Errata Sheet

Product Family:	DL405	Date:	July 16, 2019
Manual Number	D4-USER-M		
Revision and Date	4th Edition, Rev. A; March 2013

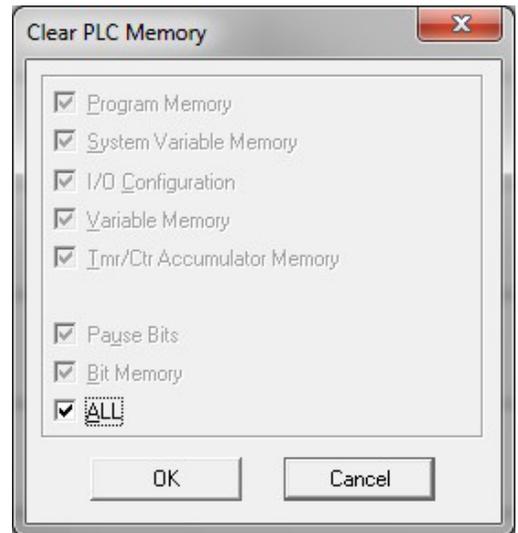
Step 1 – While connected to the PLC with DirectSoft, go to the PLC menu and select; “Clear PLC Memory”. Check the “ALL” box at the bottom of the list and press “OK”.

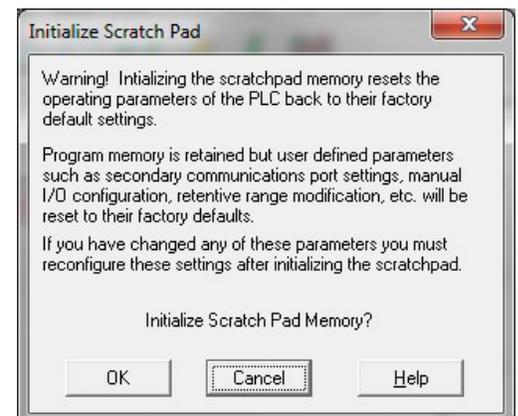
Step 2 – While connected with DirectSoft, go the PLC menu and then to the “Setup” submenu and select “Initialize Scratch Pad”. Press “OK”.
